## DEVIATION REQUEST AND DECISION FORM

Project Name :	The Shire at Old Ranch
Schedule No.(s) :	
Legal Description :	S2S2SW4 Sec 23-12-66

# Site Plan

Howells Rd. entrance to The Shire at Old Ranch

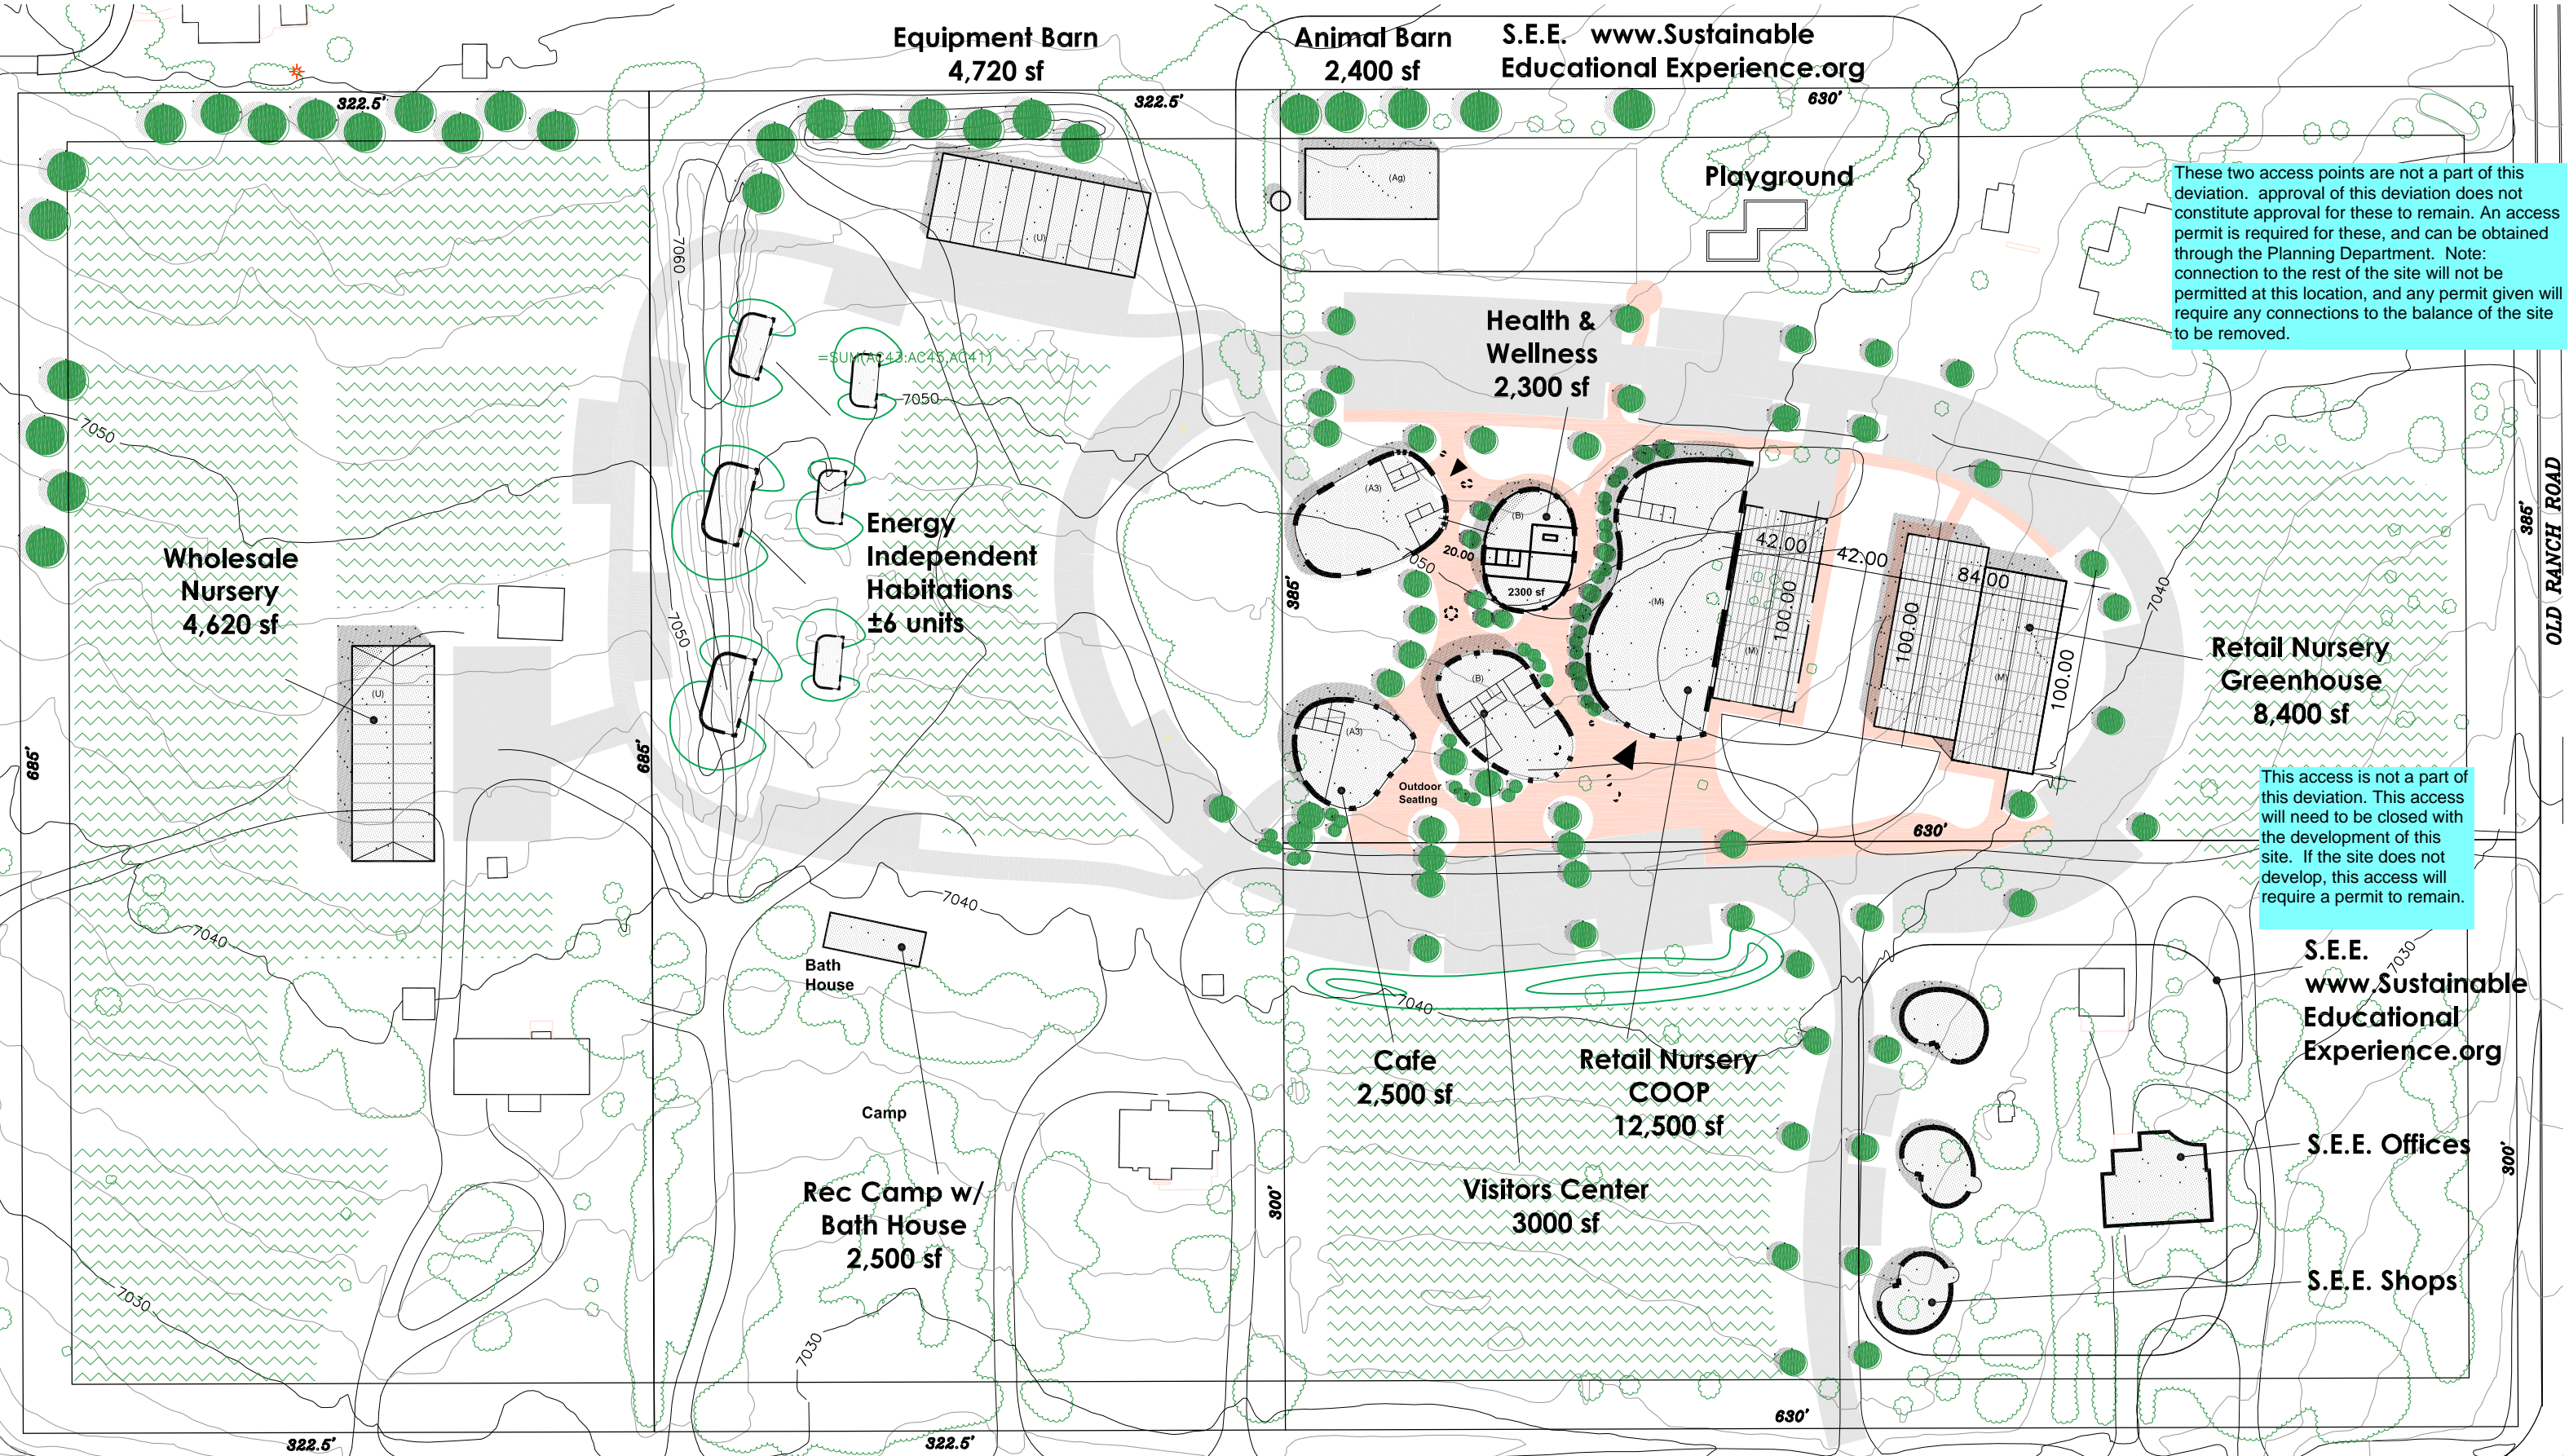
These two access points are not a part of this deviation. approval of this deviation does not constitute approval for these to remain. An access permit is required for these, and can be obtained through the Planning Department. Note: connection to the rest of the site will not be permitted at this location, and any permit given will require any connections to the balance of the site to be removed.

This access is not a part of this deviation. This access will need to be closed with the development of this site. If the site does not develop, this access will require a permit to remain.
